REMARKS

The advantages of the present invention are clearly apparent over the art and not disclosed or suggested anywhere in the prior art. Accordingly, withdrawal of the rejections is respectfully requested and allowance of claims 12, and 17-25 is requested at as early a date as possible. This is intended to be complete response to the Official Action dated 5/4/05. PTO form 2038 is submitted herewith.

DRAWINGS

Fig. 2

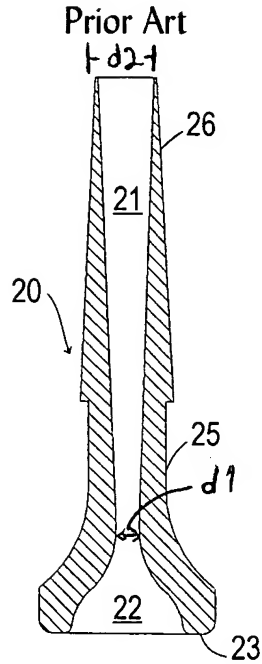
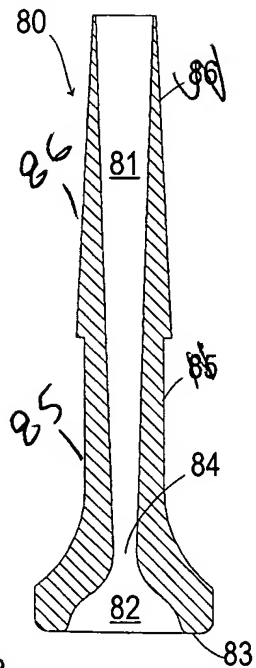
Response to Item 1 DRAWINGS: The Applicant appreciates and agrees with PTO findings stated in Reference to 37 CFR 1.83(a). New 37 CFR 1.121(d) appropriate drawings are submitted herein with particular attention to showing (d1), (d2), (L1), (L2) and (L3) as requested. Withdrawal of the objection is kindly requested.

Amended drawing containing Figures 2 and 8 have PTO-suggested markings for the location of variables d1, d2, L1, and L2. Additions to Figures 4 to 7 find support in combination of the original "12-Step method", Claims 9, Claim 12, Figure 9, and the Applicant's original element numbering system.

Fig. 9

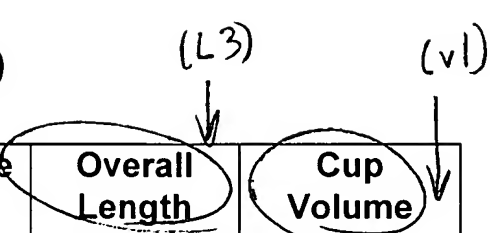
Amended drawing for Figure 9 has only symbols "v1" and "L3" placed next to prior-established written descriptions for v1 and L3 as supported by the original "12-Step method".

Fig. 10 X ~~Prior Art~~

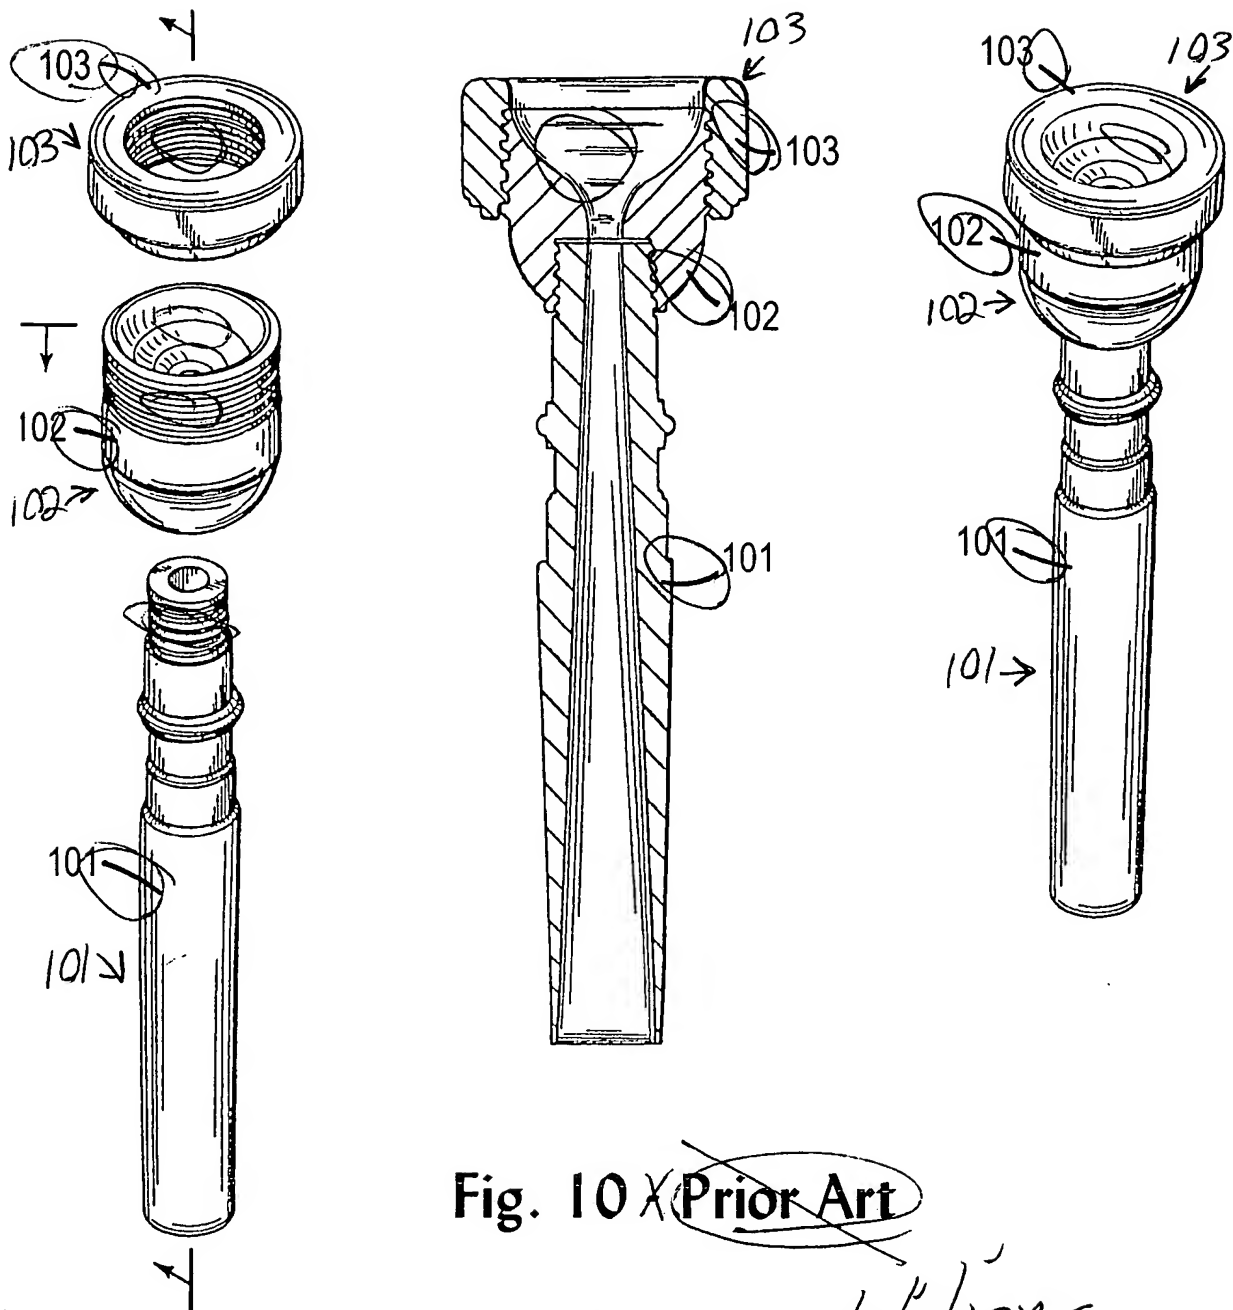
Response to Item 2 DRAWINGS: The Applicant appreciates and agrees with PTO findings stated in Reference to 37 CFR 1.83(a). An additional 37 CFR 1.121(d) compliant drawing sheet now shows views of previously disclosed combinations for divisible mouthpiece sections. Withdrawal of the objection is kindly requested.

Amended drawing for Figure 10 has been corrected to present previously introduced elements (in page 17 of originally filed Specification, Claims 3, 4, & 5, and original Figure 10), for multiple views of a sectioned mouthpiece based upon original elements **81**, **82**, **83**, & **86** and using the drawing style of Shepley. The words "Prior Art" have been intentionally removed since the previously disclosed elements of page 17 , Figure 8, and sections form a dependent Fortiori patentable over prior-art (based upon the novel proportions and sizes of elements **81** & **82**). Note that novel backbone length **82** is scaled much longer than the prior-art backbone originally shown as element **101**. Cup-chamber **82** also scales much shorter than shown in original Figure 10. Added element number are all supported by previously disclosed subject matter.
